trouble shooting tips

No. 11 Kraus Type A and B SKIL184 Software Swapping

January 1995

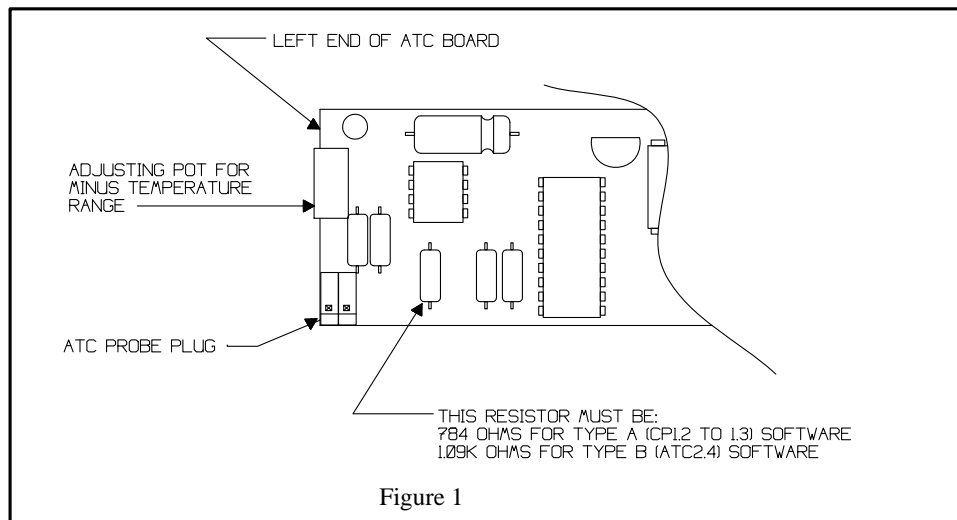
It has come to our attention that Contractors in the field are swapping Type A (CP1.2) Software for Type B (ATC2.4) Software on SKIL 184 ATC Boards, or visa versa, as a result of them changing SKIL 152 Assy 15 Controller Software.

If this is done without changing the resistor closest to the right of the ATC Probe Plug on the SKIL 184 ATC Board (as shown in figure 1) it will result in the plus temperature range being out of compensation. It will be further out the higher the temperature.

The POT on the end of the board adjusts the minus temperature and it also will have to be adjusted in the event of a software type change.

The resistor must be a 784 Ohm for Type A (CP1.2) Software and 1.09K (1090) Ohm for Type B (ATC2.4) Software. Other values will give compensation error.

ERI can change these resistors for you and test the board for operation with the software you will be putting into service!
